RE: ^{*Subdivision*} ~~Site Plan Review:~~ ~~35 Barclay Avenue~~ *Castine Avenue*
SIX ~~Three (3) Lots Subdivision~~
Application # ~~2007-0018; CBL 339 D009001~~

I am writing to follow up on the Planning Board Workshop held on April 10th, 2007 and clarify the current status of the Subdivision Review and issues that need to be addressed prior to the project being considered at a Planning Board Hearing.

Subject: Subdivision Plan Submission
Castine Avenue, Portland, Maine

Drawing Name:	Lot Layout Plan
Project:	CASTINE AVENUE, PORTLAND, MAINE
Client:	W&C, LLC PO Box 10127, 449 Forest Avenue, Portland, ME 04104

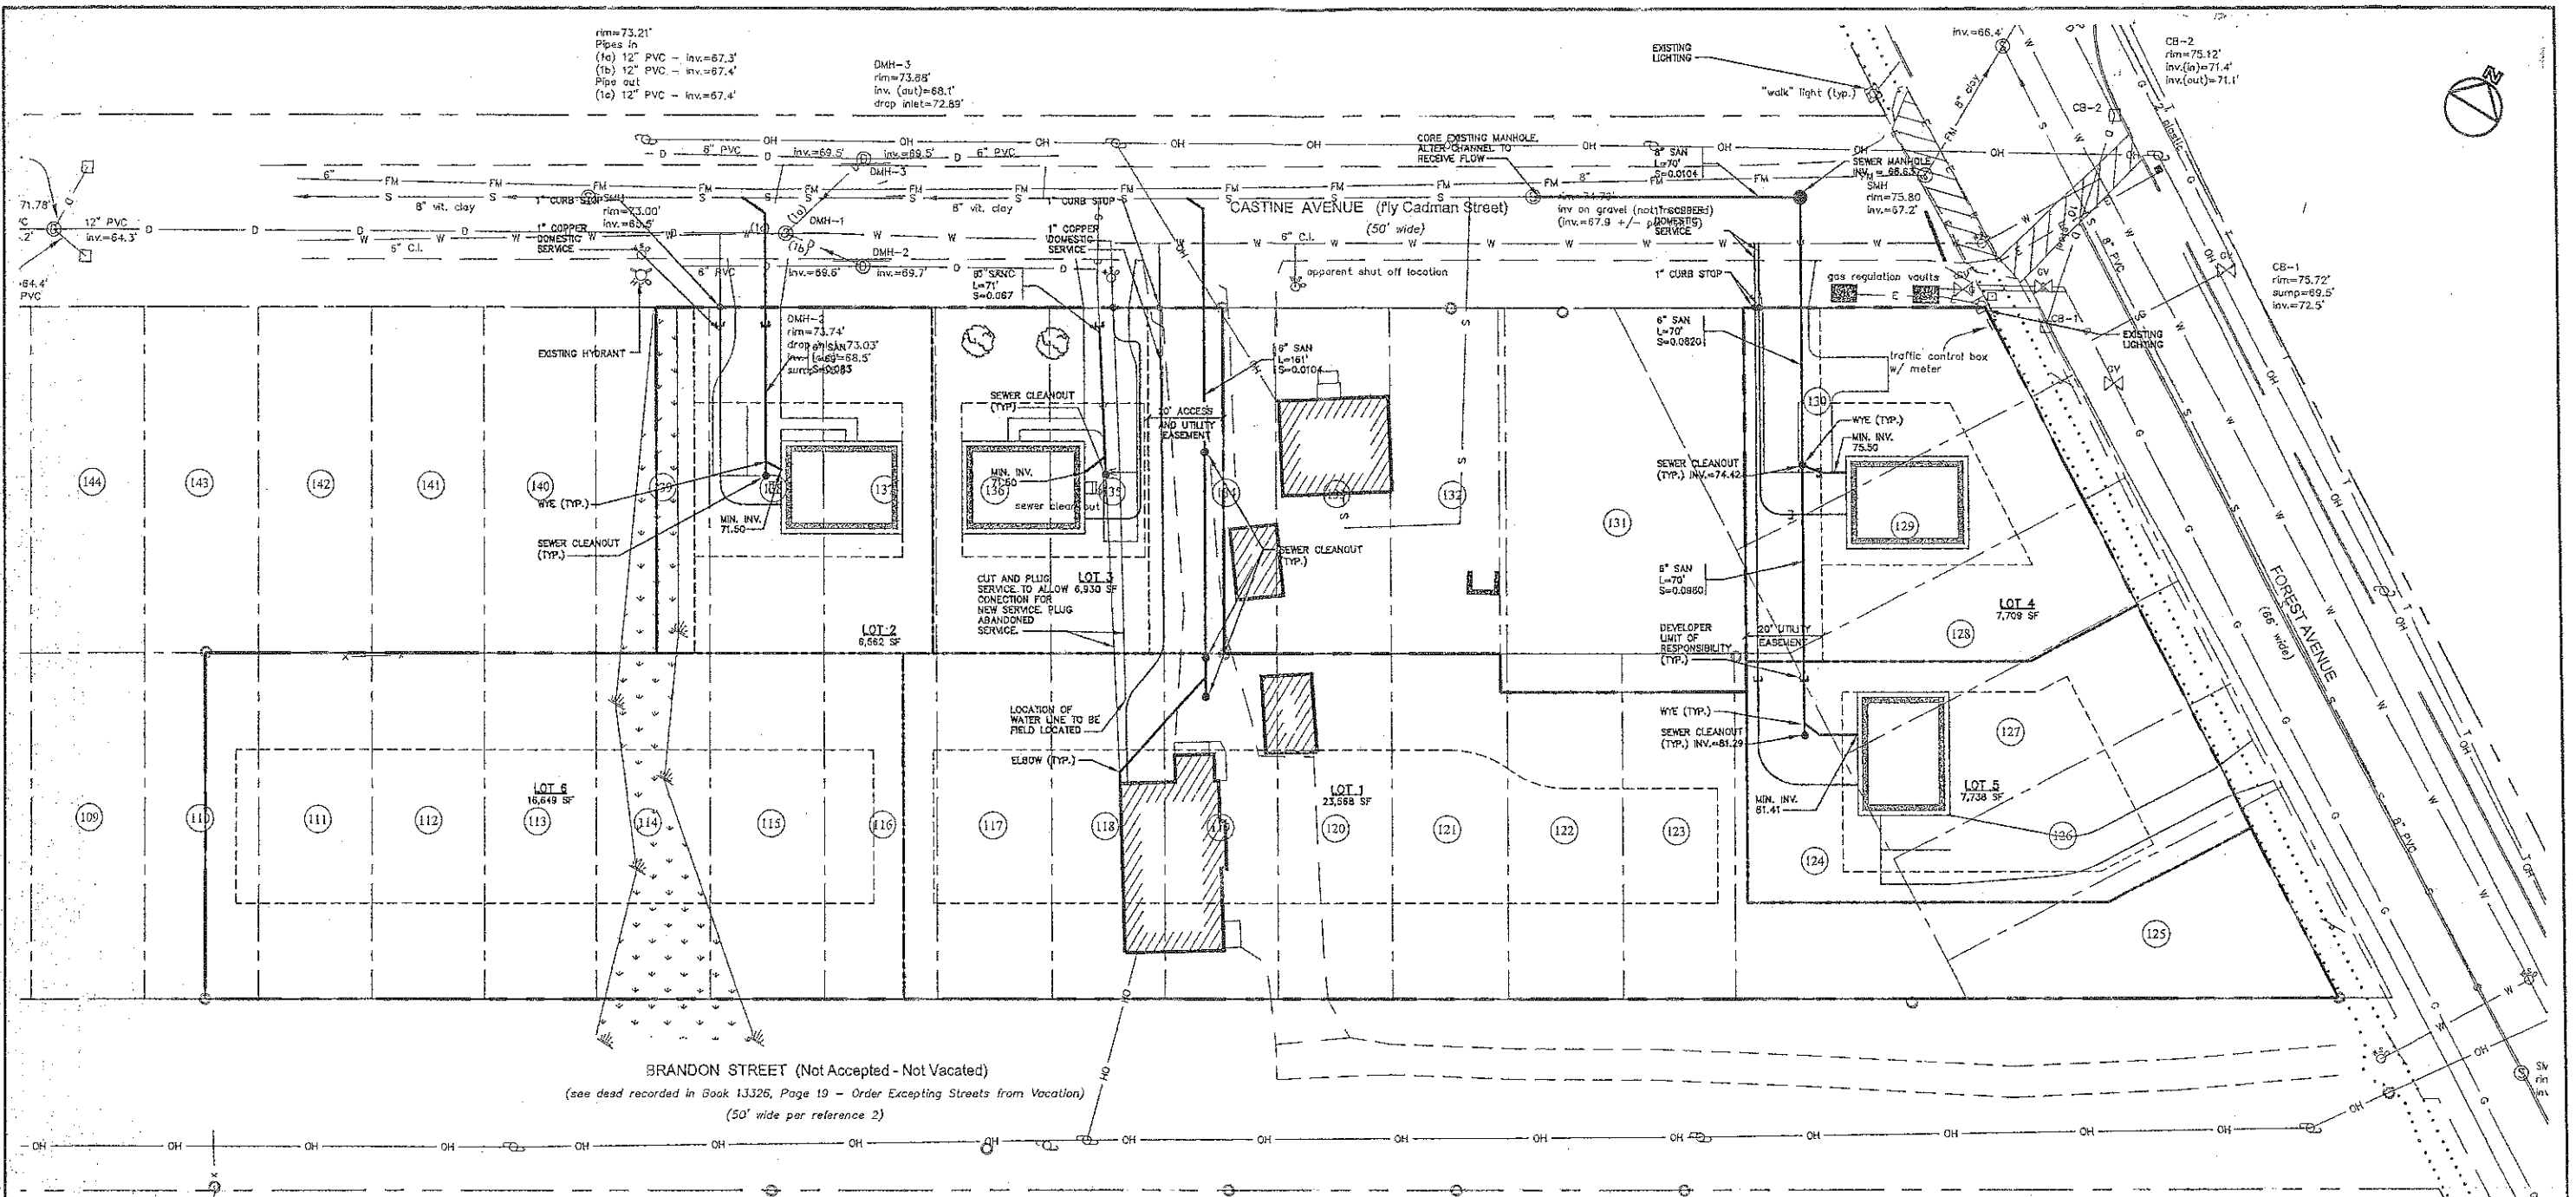
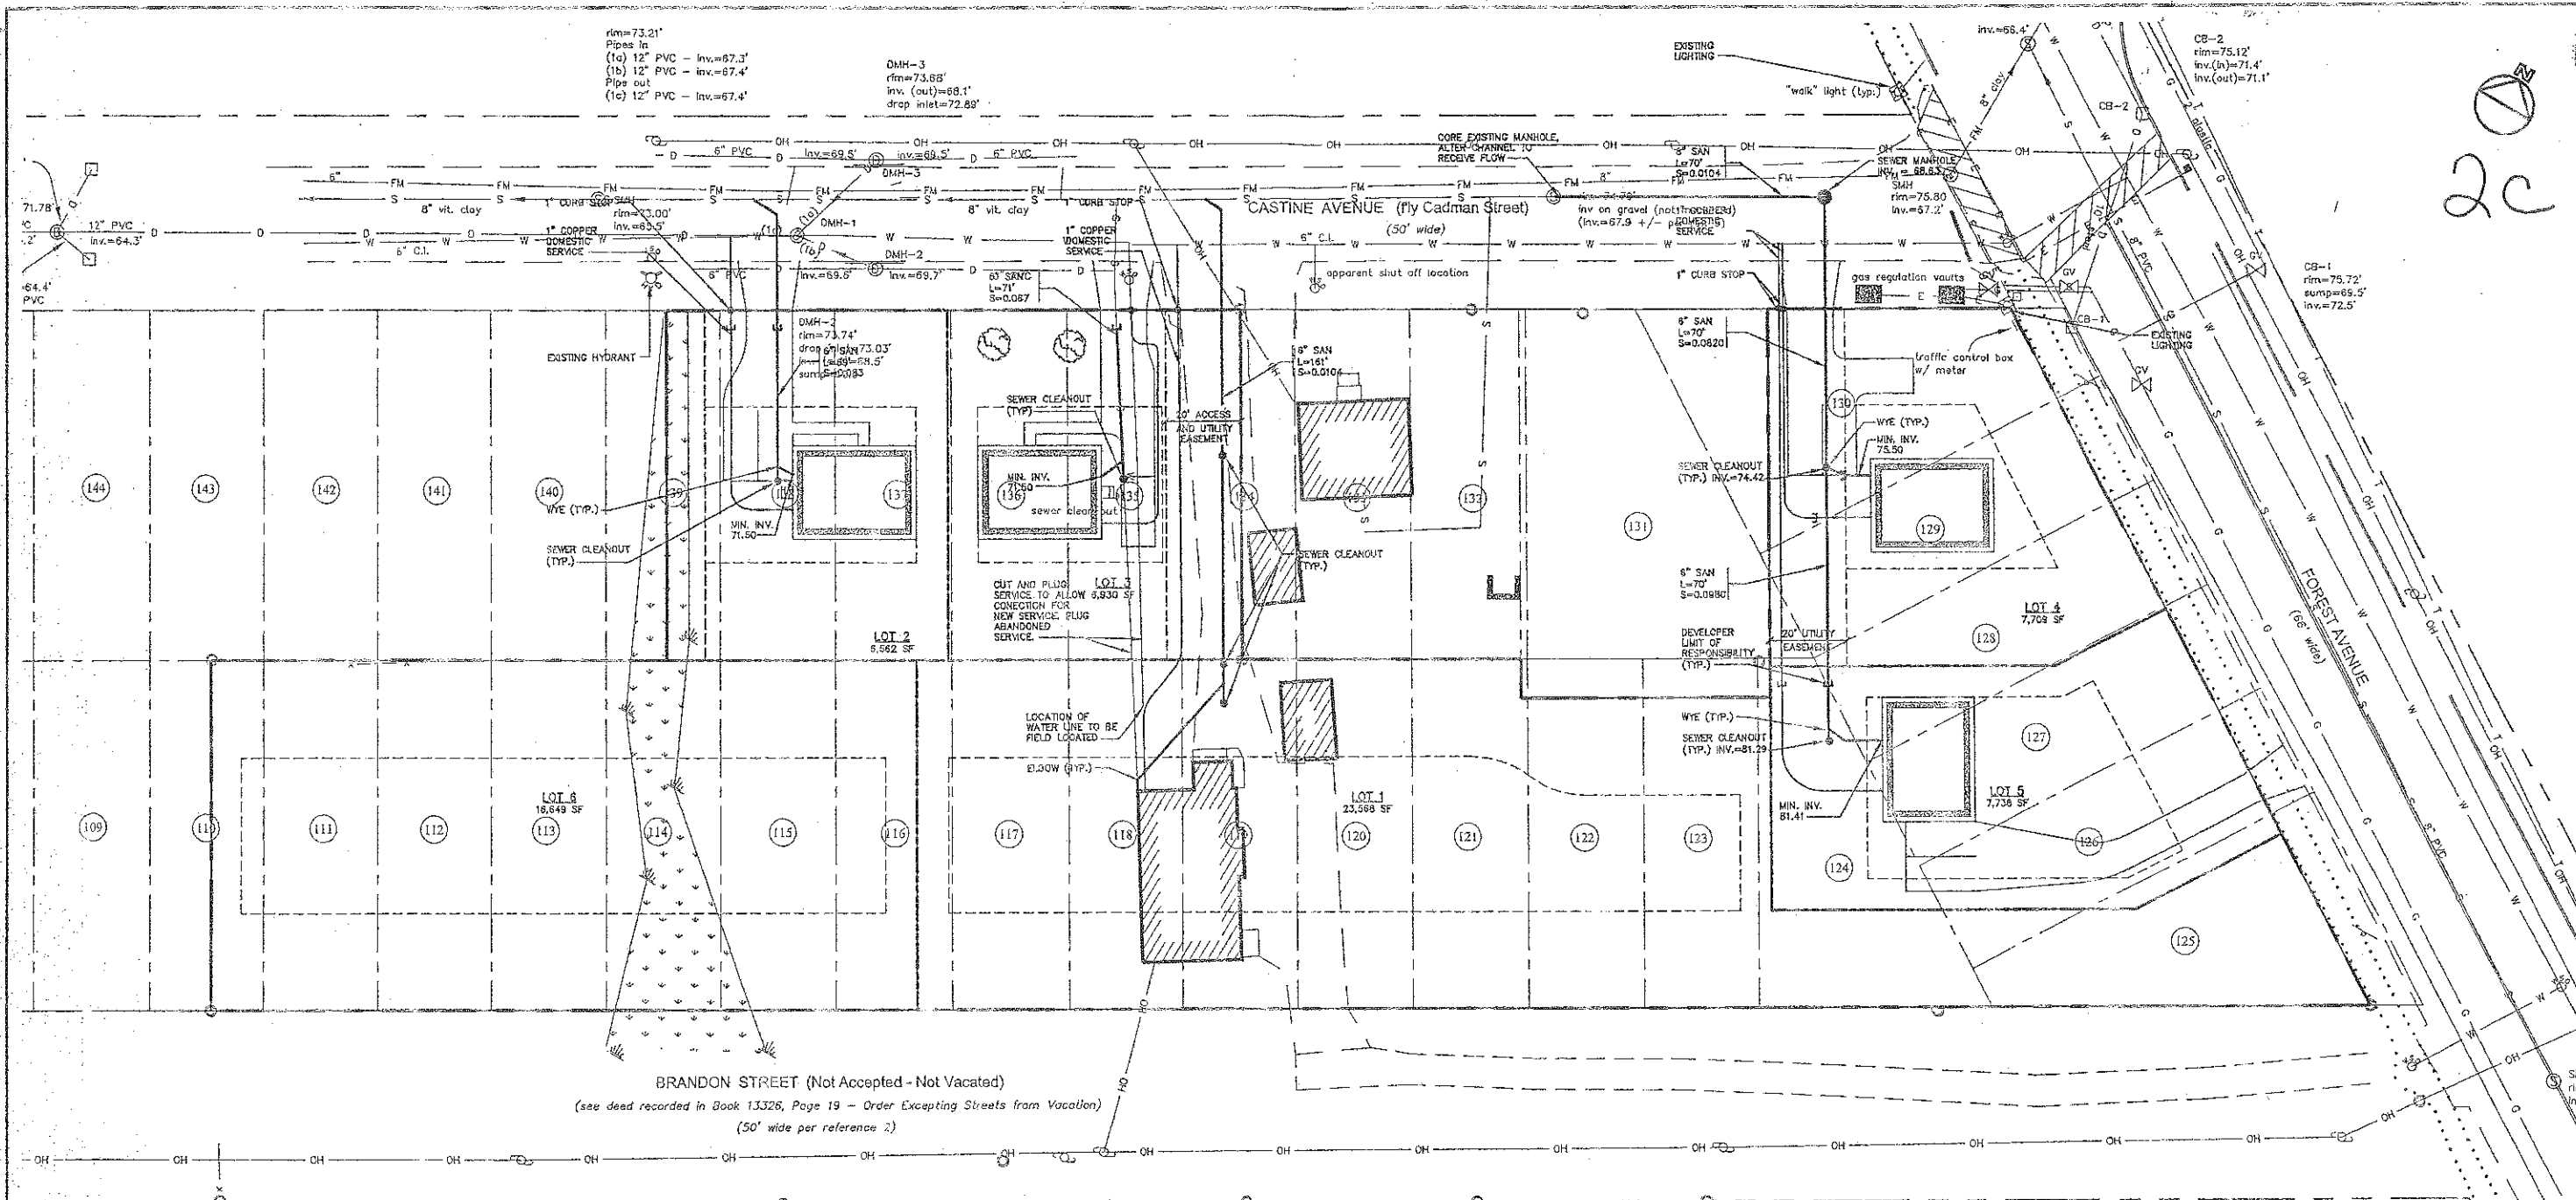
Comment 2 – Two parking spaces per lot are required and the spaces must be 9 by 19 feet. The spaces shown on the lot layout plan sheet 3 are 9 by 18 feet.

- The dimensions of the parking spaces depicted on lot layout plan sheet 3 have been revised from 9 ft. by 18 ft. to 9 ft. by 19 ft. as required by Portland City Ordinances.
